SERVICE BULLETIN

Classification: EL15-004a	Reference: NTB15-022a	Date: April 28, 2015
------------------------------	--------------------------	-------------------------

NV200 AND NV200 TAXI; CRANK NO START BELOW FREEZING AFTER OVERNIGHT COLD SOAK AND DTC U1000 STORED

This bulletin has been amended. The ACTION section has been revised, and references to Figures 4 and 5 have been corrected. Please discard previous versions of this bulletin.

Figure 1

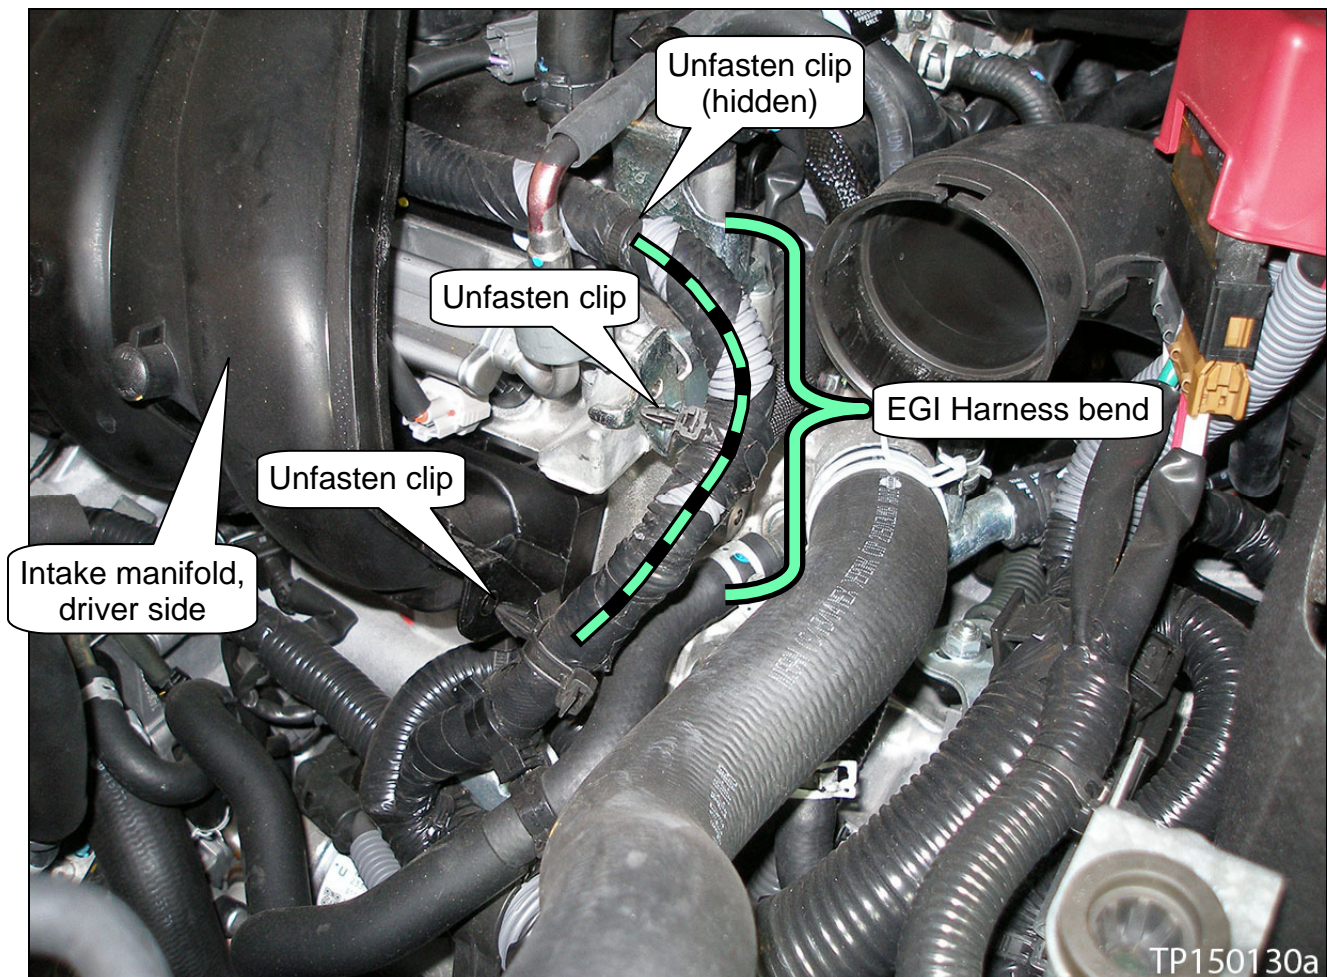
- Disconnect both battery cables, negative cable first.
 - Make sure to use suitable protection on the fenders and bumper fascia as needed.
- Remove the front air duct.
- Locate the bend in the EGI harness where shown in Figure 1.
- Unfasten the three (3) clips where shown in Figure 1.

Figure 3

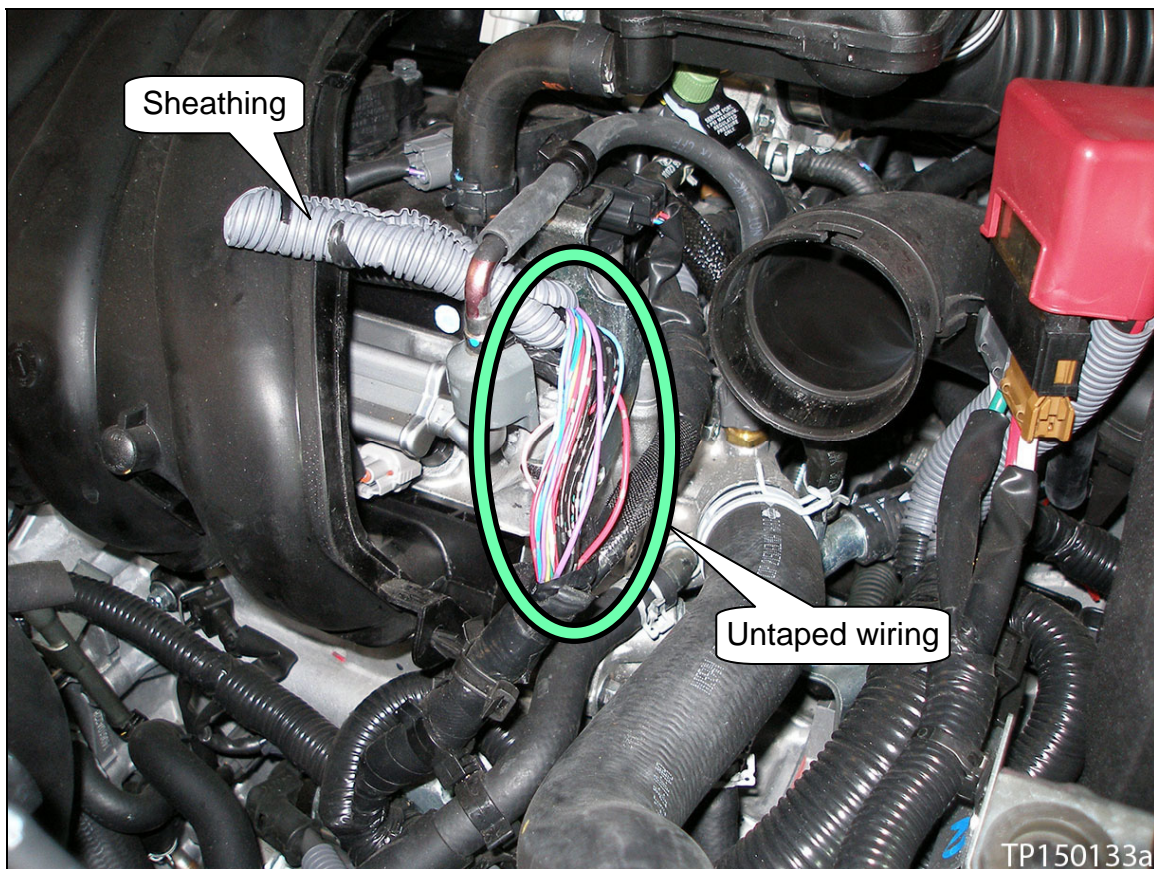
7. Untape the sheathing, and then pull back the sheathing out of the way (see Figure 3).
8. After pulling back the sheathing, untape the wiring (see Figure 3).

Figure 4

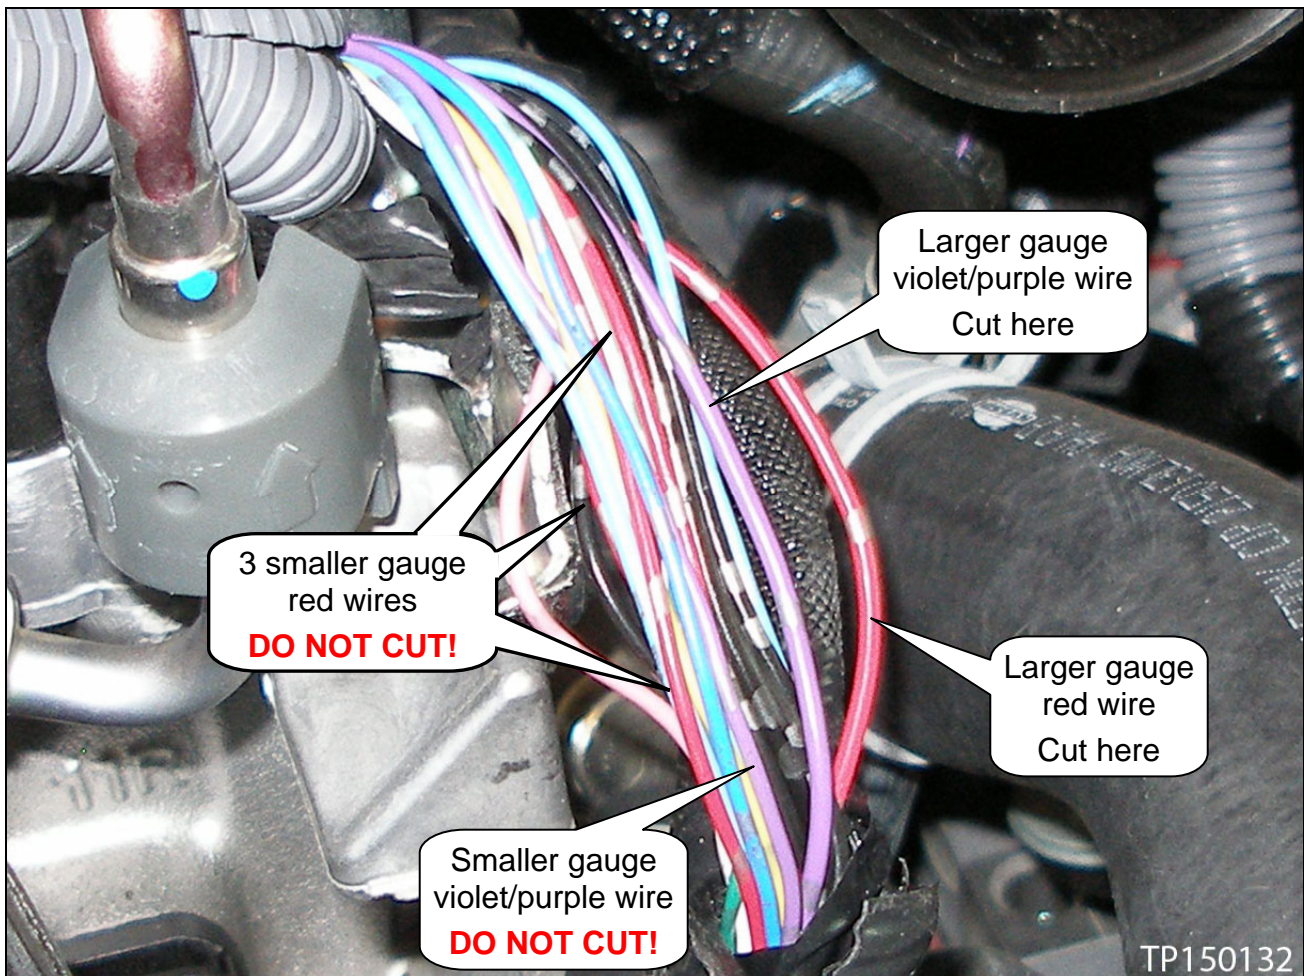
9. Locate and cut the thicker 16 Gauge/1.25 mm red wire (see Figure 4).

- Cut this wire further down the harness (see Figure 4). Leave enough length to install a piece of heat shrink tubing.

CAUTION: There are four (4) red wires in this section of the EGI harness. One is a thicker gauge (16 Gauge/1.25 mm) than the remaining three (3) wires. Make sure to cut the 16 gauge red wire.

10. Locate and cut the thicker 16 Gauge/1.25 mm violet/purple wire (see Figure 4).

- Cut this wire about in the middle of the exposed wiring (see Figure 4).

CAUTION: There are two (2) violet/purple wires in this section of the EGI harness. One is a thicker gauge (16 Gauge/1.25 mm) than the other violet/purple wire. Make sure to cut the 16 gauge violet/purple wire.

Figure 5

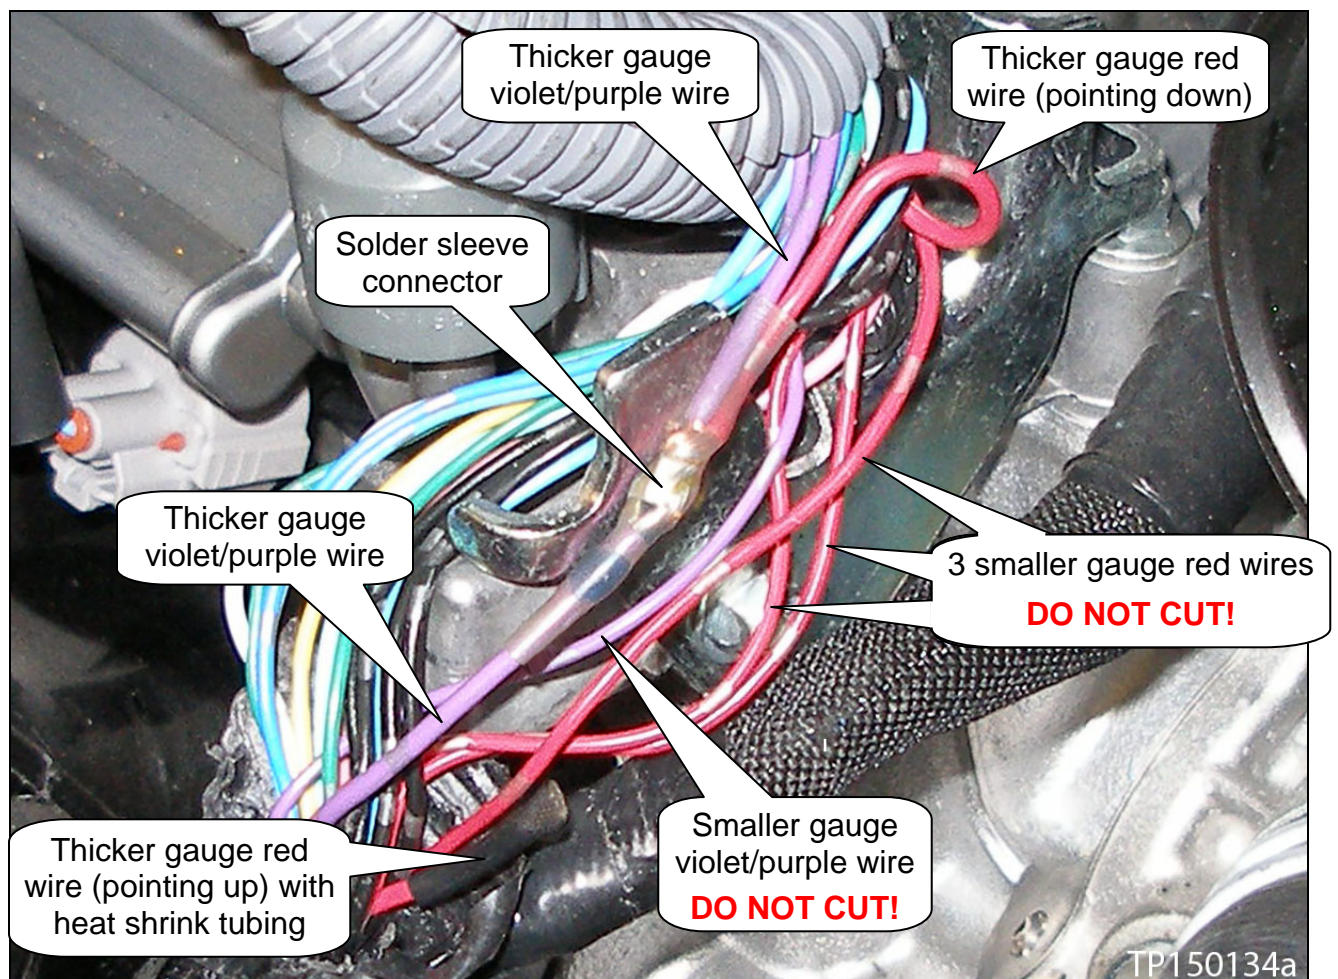
11. Connect/splice together the end of the red wire pointing down with both ends of the violet/purple wire with a “blue” solder sleeve connector (see **PARTS INFORMATION**).

- See Figure 5.
- Refer to NTB03-078 for solder sleeve connector installation procedure.

12. Place a one inch piece of heat shrink tubing on the red wire pointing up (see Figure 5).

- Leave about ½ inch of tubing past the end of the red wire.

13. Install the heat shrink tubing by applying heat with Flameless Heat Gun J-46538 or equivalent (see Figure 5).

Figure 6

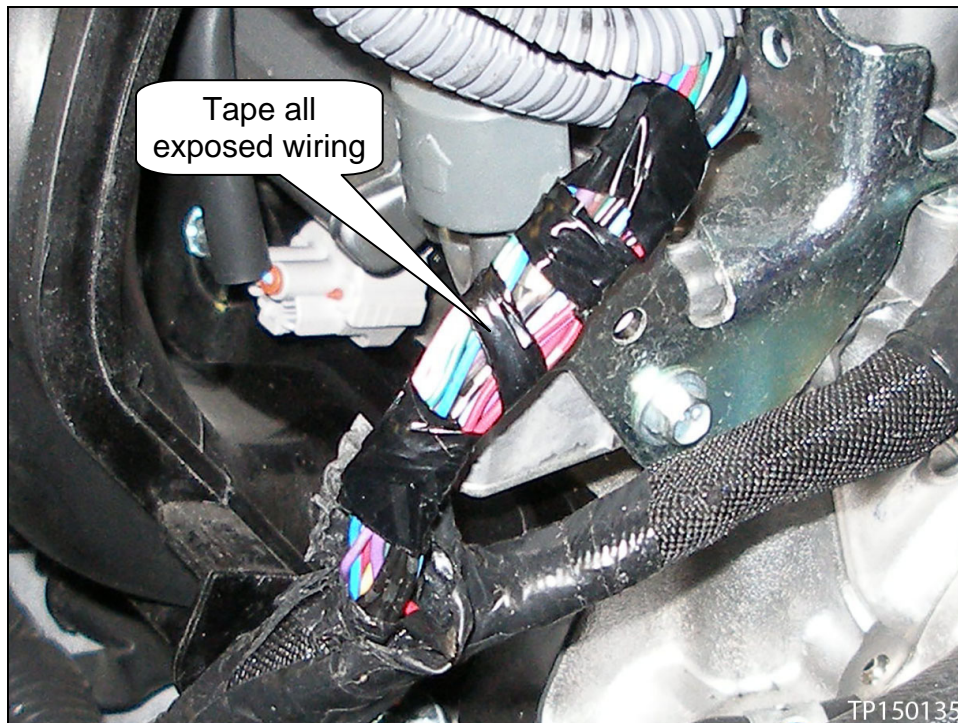
14. Wrap suitable electrical tape around all exposed wiring (see Figure 6).
